ENGINE - LP COMPRESSOR - REMOVE UNNECESSARY BLANKING PLATES AND OIL DRAIN TUBE FROM THE FAN FRAME ASSEMBLY - CATEGORY CODE 7 - MOD.ENG-72-0170

V2500-ENG-72-0170

Fan Frame Assembly - Before and After Alteration  
Fig.1 (Sheet 1 of 2)

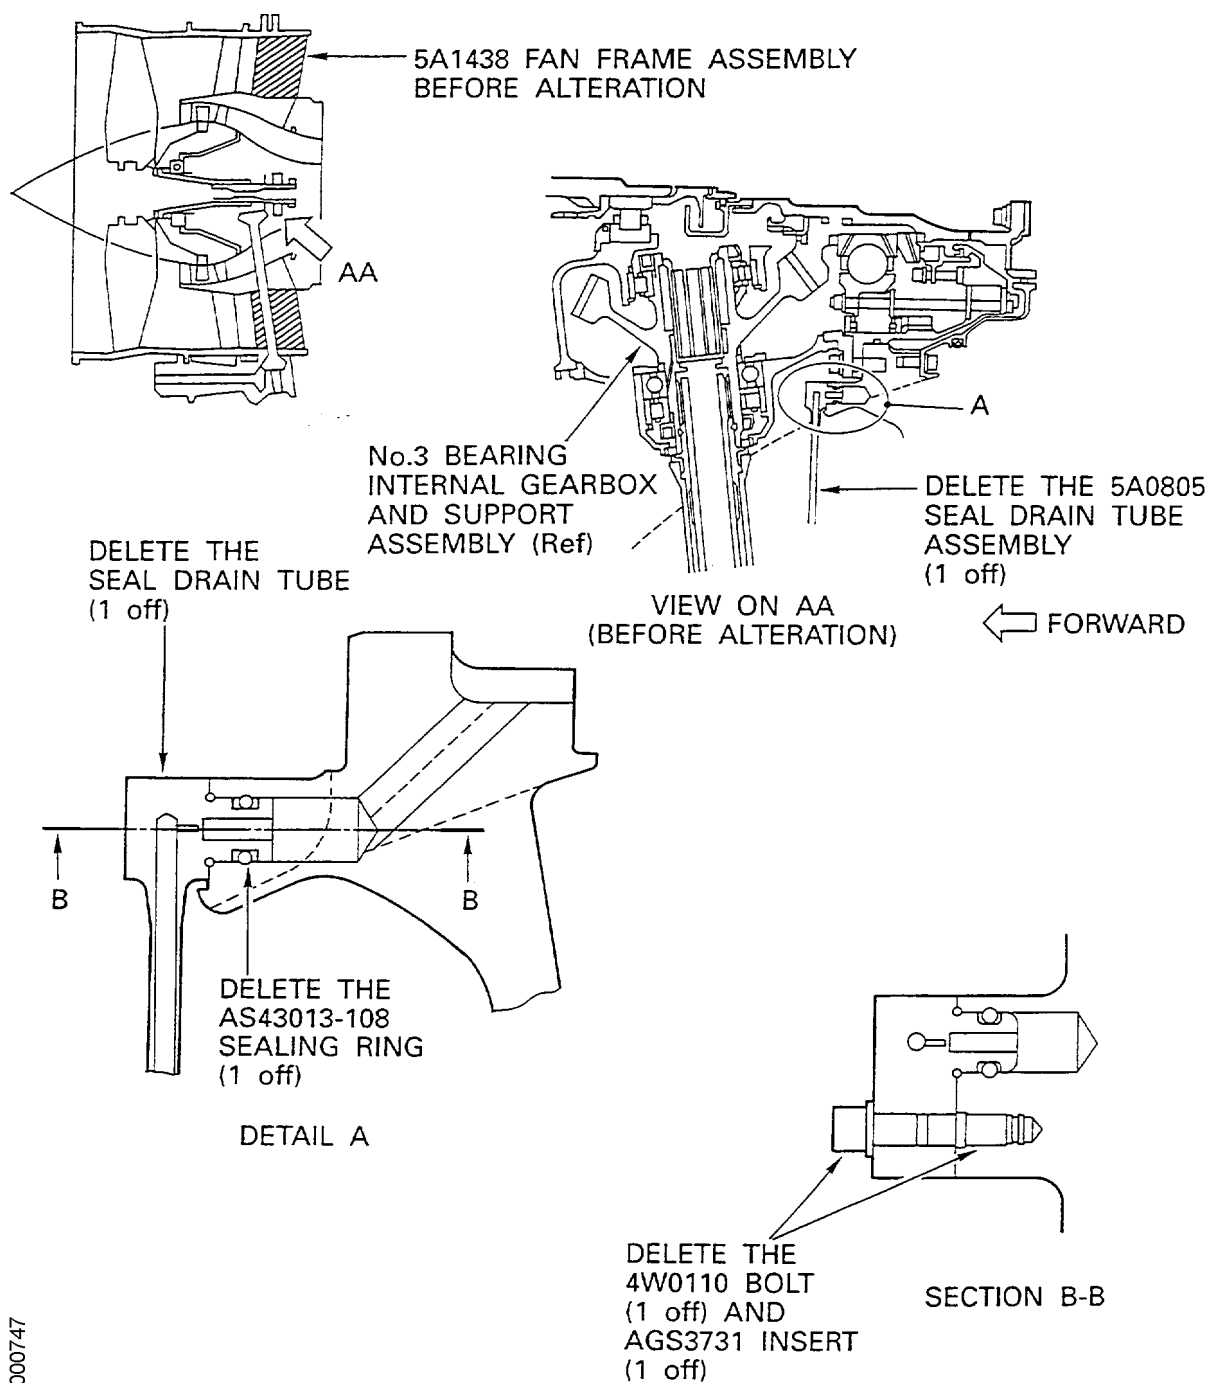
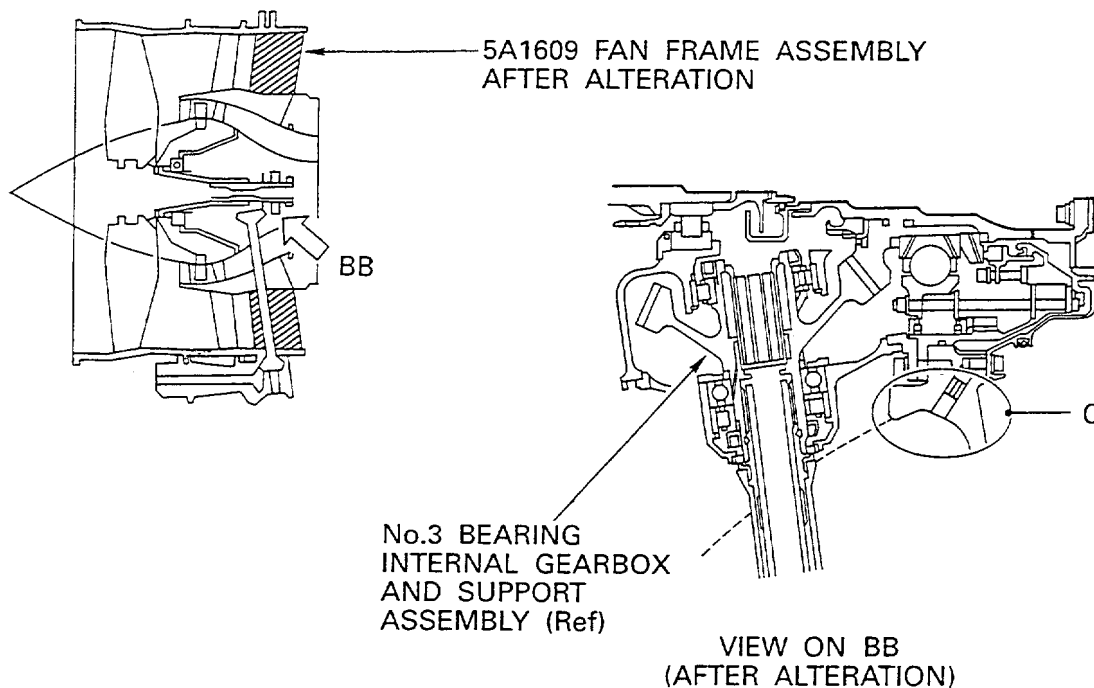
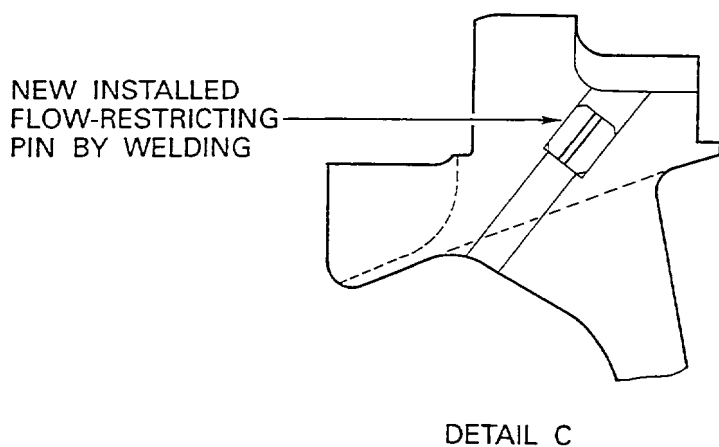
- (1) This Service Bulletin introduces the new Fan Frame Assembly as follows:
- (a) The blanking plates are deleted from inside of No.1 and No.6 bypass struts on the Fan Frame Assembly.
  - (b) Replace the seal drain tube assembly with flow-restricting pin which is fitted on the Fan Frame Assembly (See Figure 1).
  - (c) The existing bolt and sealing ring of the seal drain tube assembly have been deleted. (See Figure 1).
  - (d) Engine weight will be decreased 0.4 lb. (0,18 kg).

. Family Tree - Fan Frame Assembly Ref. Catalog Sequence No. 72-32-03 Fig. 03, Item 100  
Fig.2

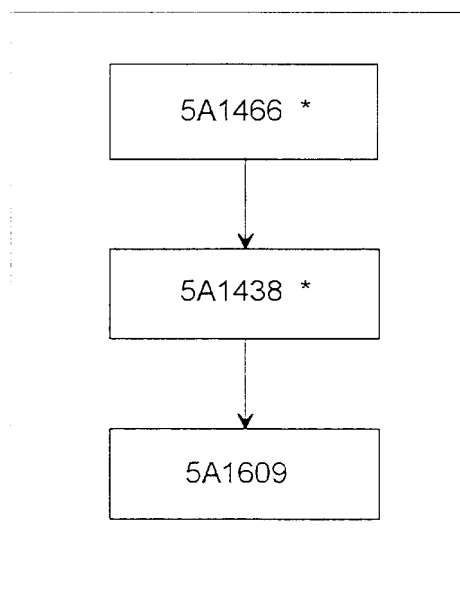
V2500-ENG-72-0170  
REMOVE UNNECESSARY BLANKING  
PLATES AND OIL DRAIN TUBE  
FROM THE FAN FRAME ASSEMBLY
